Figure 83-6—Example 10:4 PMA bit mux

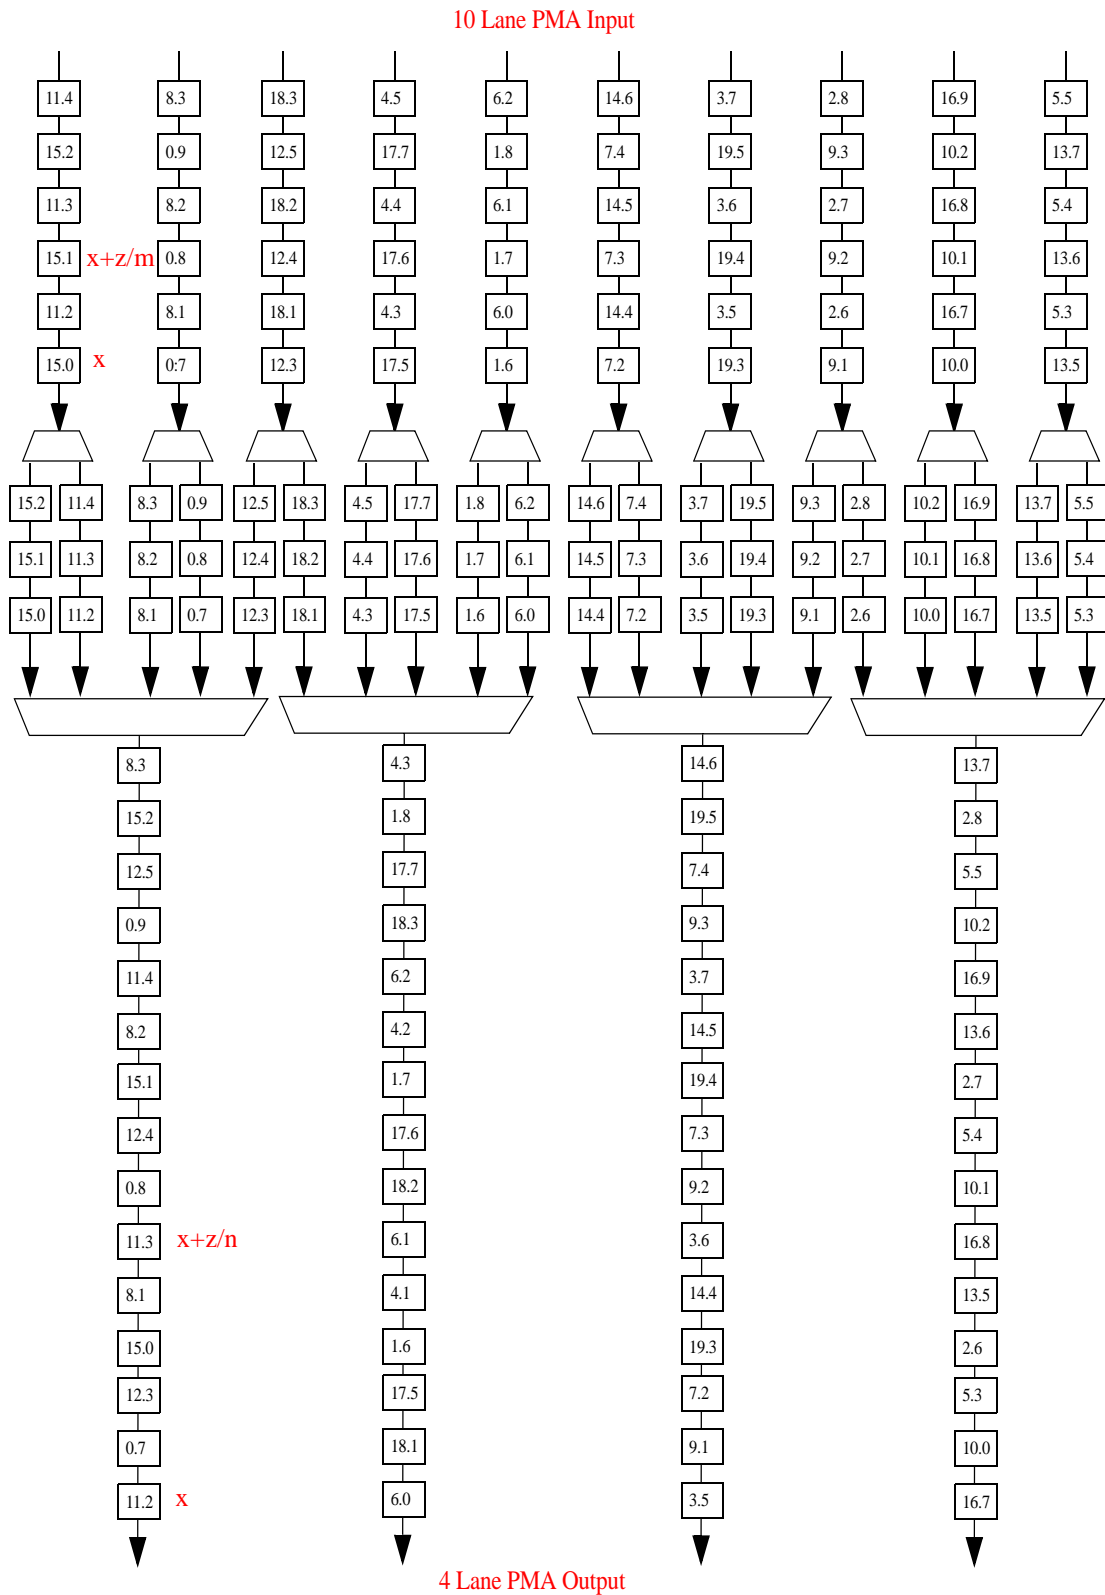
For a PMA with m input lanes (Tx or Rx direction), each input lane carries, bit multiplexed, z/m PCSLs. Each input lane has a nominal signaling rate of $R \times z/m$. If bit x received on an input lane belongs to a particular PCSL, the next bit of that same PCSL is received on the same input lane at bit position $x+(z/m)$. **If the input lane carries more than one PCSL, bit position $x+1$ belongs to another PCSL, and bit $x+1+(z/m)$ is the next bit from that same PCSL.**

For a PMA with n output lanes (Tx or Rx direction), each output lane carries, bit multiplexed, z/n PCSLs. Each output lane has a nominal signaling rate of $R \times z/n$. If bit x sent on an output lane belongs to a particular PCSL, the next bit of that same PCSL is sent on the same output lane at bit position $x+(z/n)$. **There are no restrictions on the sequencing of the z/n PCSLs onto the respective output lane.**

Each PCSL received in any temporal position on an input lane is transferred into a temporal position on an output lane. As the PCS (see Clause 82) has fully flexible receive logic, an implementation is free to perform the mapping of PCSLs from input lanes to output lanes without constraint. The only requirement is that from the time the link is brought up, each PCSL from an input lane is mapped to a particular output lane, and the input lane to output lane mapping of PCSLs is maintained. Figure 83–6 illustrates one possible bit ordering for a 10:4 PMA bit mux. Other bit orderings are also valid. **In Figure 83–6, the first number in a box is the PCSL number, and the 2nd number is the bit number.**
